# Parcel 9: Pennrose Concept Plan & Recommendation

# Design Review Panel Feedback

# Courtyard Evolution

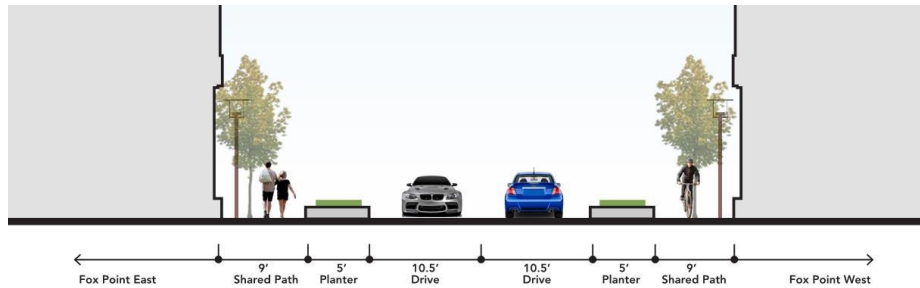
- Strengths
  - Courtyard creates strong connection between City Walk, the heart of the project, and the rest of the neighborhood
  - Emphasis on bicycle lifestyle for commuting and recreation - enclosed bicycle parking framing gateway into the project celebrates larger connections via the bicycle network
  - Lobbies and ground-level units successfully screen the enclosed parking from the neighborhood-facing public realm
- Areas for Improvement
  - Courtyard is shared by pedestrians and vehicles without adequate design cues
  - Similarity in scale and architectural expression of the two buildings gives the proposal an institutional character
  - More needs to be known about the potential uses or tenants in the ground floor commercial spaces at the building corners facing Alves Way

# Ground Floor Activation: Food/Beverage Tenant

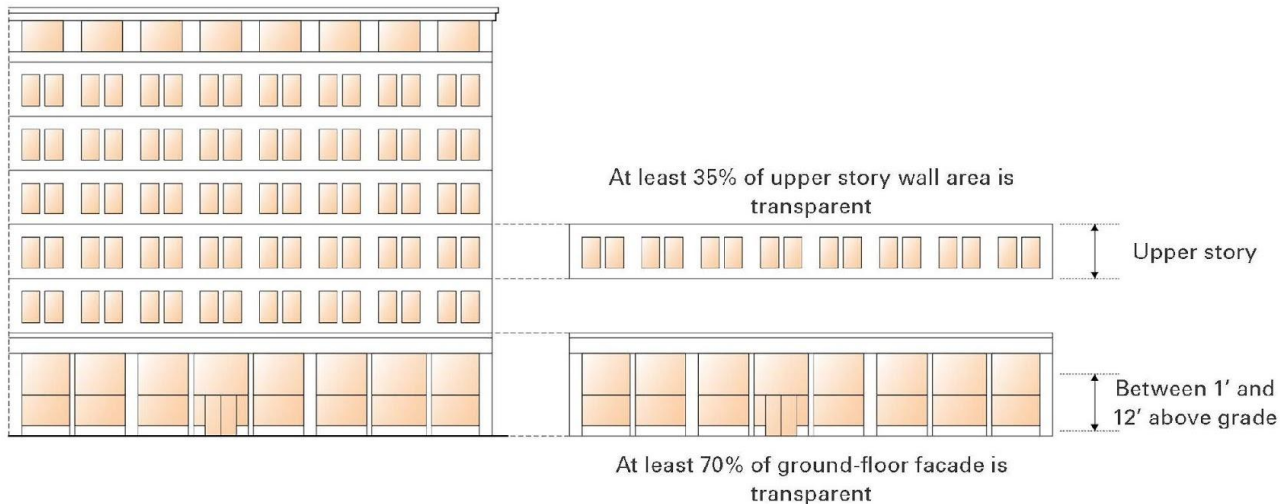
Corner of Alves Way & City Walk  
*(catty-corner to future grocer at S. Main & Pike)*
